# BIO-BUILDING DESIGN

## **PROPOSED ALTERATIONS & ADDITIONS TO EMU SPORTS CLUB 1 LEONAY PARADE, LEONAY ACCESS & MOBILITY REPORT**

Photograph 1: Present main entry to Emu Sports Club

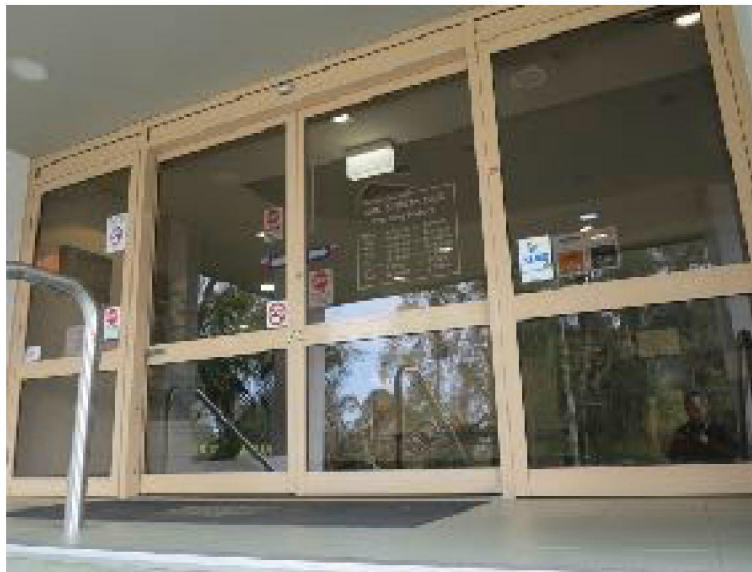
- ❑ It is proposed to provide a new passenger lift at the Principal Pedestrian Entry, as shown on the Proposed Ground and First Floor Plans. The location of the proposed lift will be adjacent to the existing entry stairs shown in Photograph 1 below.

At present, there is no dignified way for people who use wheelchairs to enter the premises at the principal pedestrian entry. The existing entry consists of two

flights of stairs, having 5 risers and 10 risers respectively. There is no ramp at the front entry. The existing entry stairs are shown in Photograph 1 above.

The proposal to provide a new lift at the principal pedestrian entry is a major improvement in access for people with disabilities.

**RECOMMENDATION 1: The proposed lift shall comply with AS 1735.1, and AS 1735.12, shall have lift floor dimensions of not less than 1100 mm wide x 1400 mm deep (preferably larger), and shall include the accessible features listed in BCA Table E3.6 (b).**

Photograph 2: Present automatic-opening doors at main entry to Emu Sports Club

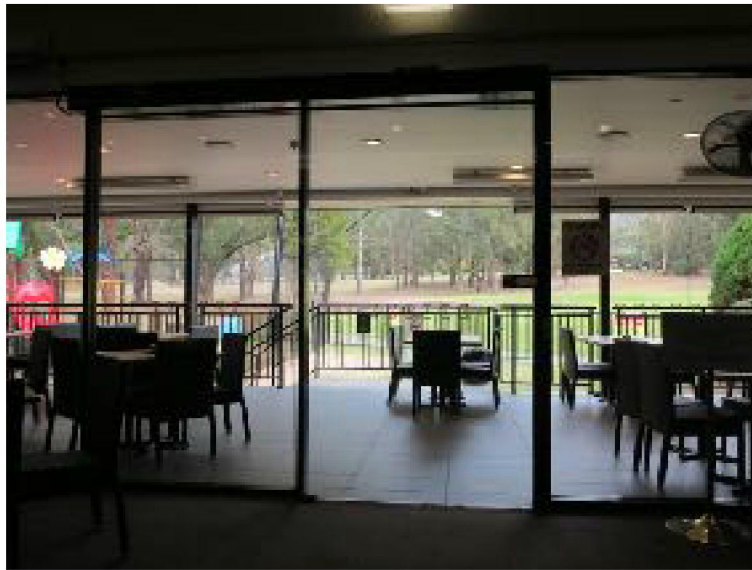
- ❑ The present entry stairs have goings of 300 mm, with risers of 175 mm, with handrails at both sides and also at the centre.
- ❑ At the top of the stairs are automatic opening entry doors with a clear opening width of 2100 mm. These doors are shown in Photograph 2 below.

The existing automatic-opening doors at the Principal Pedestrian Entry comply with the requirements of the BCA and the Access Code.
